66000A-06

S E R V I C E N O T E

66000A DC Power Supply Main Frame

The modules or the Mainframe will not communicate or will not complete self test.

Figure1

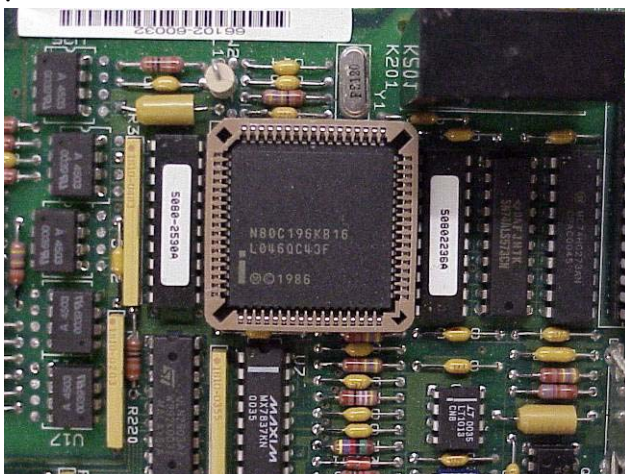
Figure 1 will help to identify the **68-PIN PLCC SOCKET location** - P/N 1200-1274 (Circuit Reference “U44”)

Figure 2

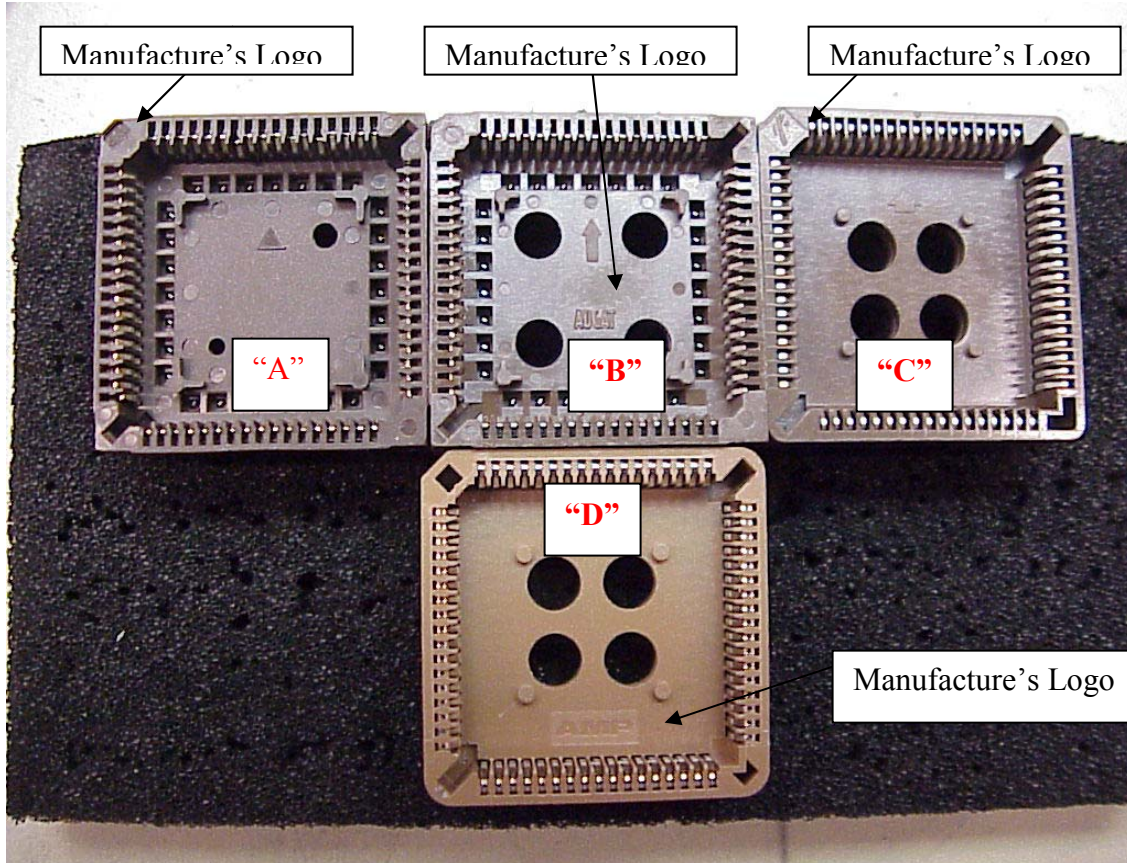
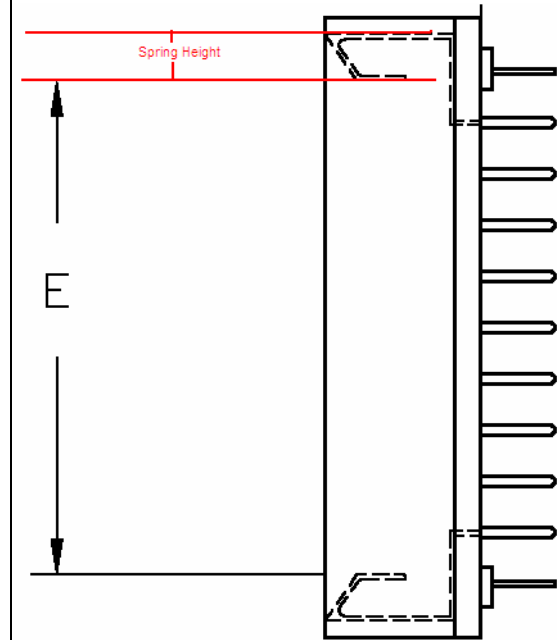
This figure should be used to identify **GOOD** sockets and a potential defective socket. The **16-Bit MCU 16 MHZ 68PLCC CMOS IC** (P/N 1821-1479) is **NOT** pictured.

- Socket **"A"** is a sample of a GOOD AMP socket.
- Socket **"B"** is a sample of a GOOD Tyco/Augit socket.
- Socket **"C"** is a sample of a GOOD FCI socket.
- Socket **"D"** is a sample of a DEFECTIVE Tyco socket.

The sockets above labeled **"A", "B" or "C"** are good and should NOT be replaced.
The socket above labeled **"D"** is considered defective should be replaced.

Discipline B – Verification of Corrective Action “The socket shown in the pictures are for reference ONLY”

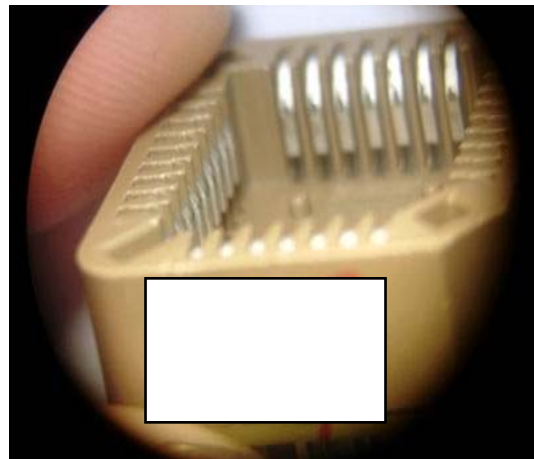
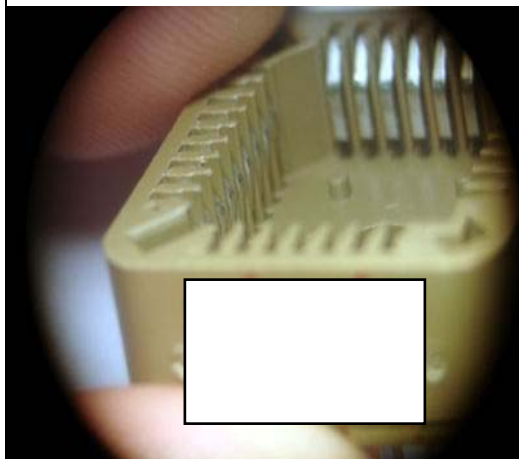
The condition of the recessed beams has been corrected by a design enhancement implemented in production. This design enhancement increased the spring height dimension by 0.04mm and decreased the spring height tolerance by 40%. The spring height dimension is shown in the drawing below.

This design enhancement is intended to position the contact beams closer to the middle of the socket and increase the normal force exerted on the contacts of the chips mated to the socket.

The effectiveness of this design enhancement was tested by comparing the mating and un-mating forces on the older and newer designs. The test results for sockets with the increased spring height (newer design) showed an increase in the mean mating force of 18.9% and an increase in the mean un-mating force of 23.4%. The increase in the un-mating force test results between the old design and the new design indicate that a greater normal force is being exerted on the test chip contacts by the socket contact beams. The two revisions of this contact beam design were visually examined after the mating and un-mating force testing. Photos of the two sockets are shown below. The photo on the left shows the older version socket prior to the enhanced contact beam design. The photo on the right shows a socket with the design enhancement. The contacts with the older design appear to be recessed farther into the housing after un-mating.
